[Docket No. 2003-SW-21-AD; Amendment 39-13424; AD 2004-01-10]

Airworthiness Directives; Eurocopter Deutschland Model MBB-BK-117 A-1, A-3, A-4, B-1, B-2, and C-1 Helicopters

ACTION: Final rule; request for comments.

Figure 1

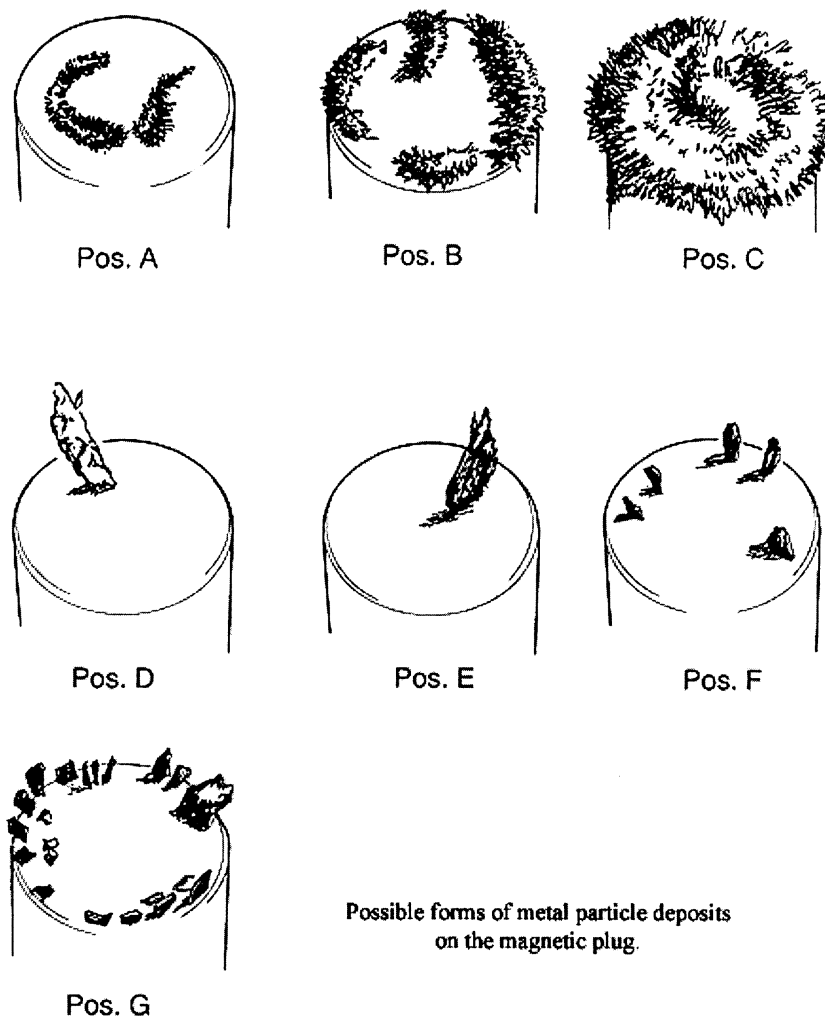
(a) Until you do paragraph (b) of this AD, before the first flight of each day, inspect the magnetic plugs of the TR transmission and INT gearbox for metal particles deposits by reference to Figure 1 of this AD.

(1) If you find a small amount of fine fuzz as shown in "Pos. A" of Figure 1 of this AD, clean the magnetic plug and reinstall it after ensuring that the O-ring is correctly positioned and there is no other damage.

(2) If you find an amount of fuzz as depicted in "Pos. B" or "Pos. C" or metal chip(s) as depicted in "Pos. D" through "Pos. G" or a combination of both fuzz and chips, do paragraph (b) of this AD.

(b) No later than February 23, 2004, replace bearing, P/N 4639310006 with S/N 3246 through 3598, with an airworthy bearing or replace the affected TR transmission or INT gearbox with an airworthy TR transmission and INT gearbox that does not contain the affected bearing.
